INTERPRETIVE OPINION

Docket: **DCAB 2003-08:** Attached are several handrail design cross sections. Do any of these designs provide an equivalent gripping surface per ADAAG 4.26.2 and 4.26.4?

Handrail cross sections:

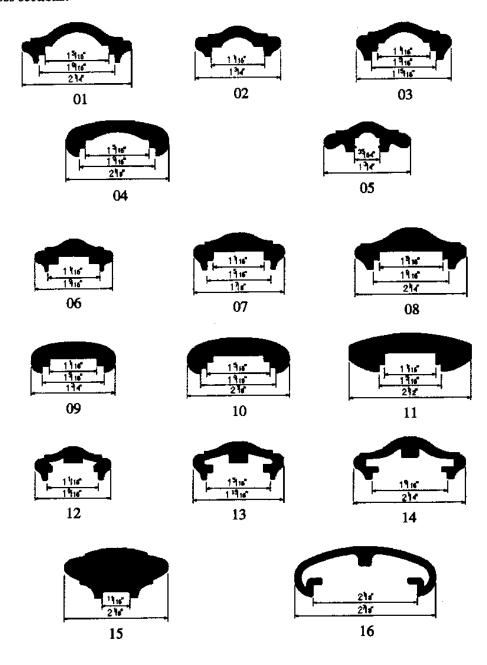
<u>Summary</u>: The ADAAG Section 4.26.2 states that the diameter or width of the gripping surface of a handrail shall be 1-1/4 inches to 1-1/2 inches, or the shape shall provide an equivalent gripping surface. The ADAAG Section 4.26.4 states that edges shall have a minimum radius of 1/8 inch. Both the U.S. Department of Justice and U.S. Access Board stated that the attached handrail cross sections do not appear to comply with the ADAAG, because the width of all the handrail cross sections are greater than 1-1/2 inches.

The attached handrail cross sections do not comply with the ADAAG Sections 4.26.2 and 4.26.4.

The Committee concluded that the handrail cross sections are not in compliance with the currently enforceable ADAAG, but felt that there are options available to a designer, which could allow the use of decorative handrails. The options discussed by the Committee include:

- Designers could submit a request for site specific alternate design.
- Decorative handrails could be used if deemed necessary to maintain the historic significance of the building or facility.
- Designers could design a guardrail with the decorative handrail cross section as a cap, and mount an ADAAG compliant handrail to the side of the guardrail. This design will have some decorative characteristics, while complying with the ADAAG.
- Decorative handrail cross sections could be used at stairs that are not required to comply with the ADAAG. Per the ADAAG Manual, stairs do not have to comply with the ADAAG where vertical access (i.e., ramp, elevator, or lift) are provided. However, compliance is still a good idea for individuals that may have difficulty walking, who prefer stairs to ramps or a wheelchair lift.
